# Access Compliance Report

## Public Rights-of-Way

### (Curb Ramps)

Intersection ID: N/A	Main Street: POTOMAC_RIVER_PY	Cross Street: NATIONAL_AV	Location: SE
ADA ID: EB6BB069CD0E	Ramp Type: Directional1	Initial Pass/Fail: Fail	Overall Compliance: No
Codes/Mitigation Info/Possible Solution		Field Measurements/Component Compliance	
Severity Score: 25

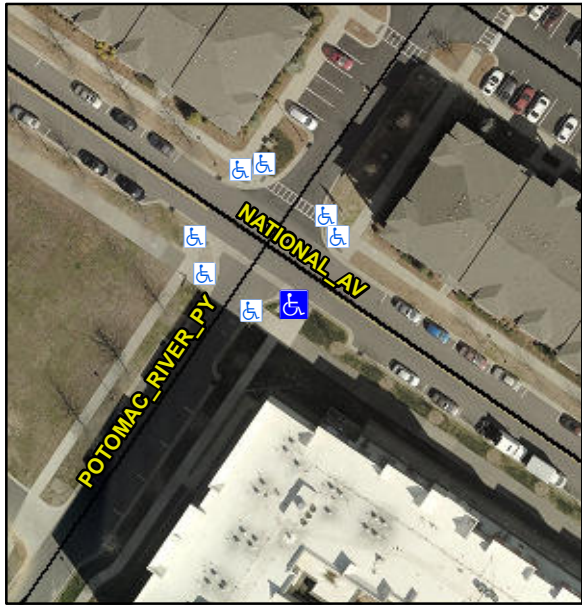
Remove & Replace Entire Ramp.

R304.5.3

Compliance	Description	Data	Compliance	Description	Data
N/A	Ramp Length (in)	76.0	N/A	Grade Break?	N/A
Yes	Ramp Width (in)	52.5	N/A	Grade Break Slope (%)	0.0
Yes	Ramp Slope (%)	5.8	N/A	Grade Break XSlope (%)	0.0
No	Ramp XSlope (%)	7.5			
N/A	Flare Type LT	N/A	N/A	Flare Type RT	N/A
N/A	Flare Slope LT (%)	N/A	N/A	Flare Slope RT (%)	0.0
N/A	Flare Traversable LT?	N/A	N/A	Flare Traversable RT?	N/A
N/A	Landing Length (in)	0.0	N/A	DWS Provided?	N/A
N/A	Landing Width (in)	0.0	N/A	DWS Contrast?	N/A
N/A	Landing Slope (%)	0.0	N/A	DWS Length (in)	N/A
N/A	Landing X Slope (%)	0.0	N/A	DWS Full Width?	N/A
N/A	Landing Curb? (Y/N)	N/A	N/A	DWS Offset LT (in)	N/A
N/A	Shared Landing?	N/A	N/A	DWS Offset RT (in)	N/A
N/A	Gutter Ponding?	0.0	N/A	Gutter Slope (%)	N/A
N/A	Gutter Lip Ht (in)	0.0	N/A	Gutter X Slope (%)	N/A
N/A	Painted X Walk1?	No		Road Slope (%)	5.1
	X Walk 1 Direction	To N		Road X Slope (%)	2.8
	X Walk 1 Width (in)	N/A		Clear Space?	N/A
